CHART STANDARDIZATION & PAPER CHART WORKING GROUP (CSPCWG)

CSPCWG Letter: 09/2007

Subject: Draft revision M-4 Section B-440 to B-449, round 2

Suggested amendment to B-447.6

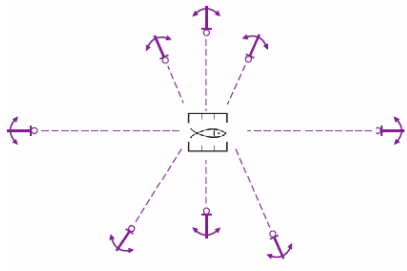
Aquaculture is a huge industry in Norway, and we are in the need of a new symbol for depicting reported ground tackle securing marine farms. The large amount of anchor chains to a marine farm may extend to a length of more than one nautical mile each. What we need is a version of symbol Q42 (B-431.6)

We suggest an additional line at the end of B-447.6, and a symbol something like the sketch below:

B-447.6 On large scale charts, the actual alignment of ground tackle securing a marine farm may be shown by fine lines in magenta

Suggestion
K 48.3
Ref Q 42
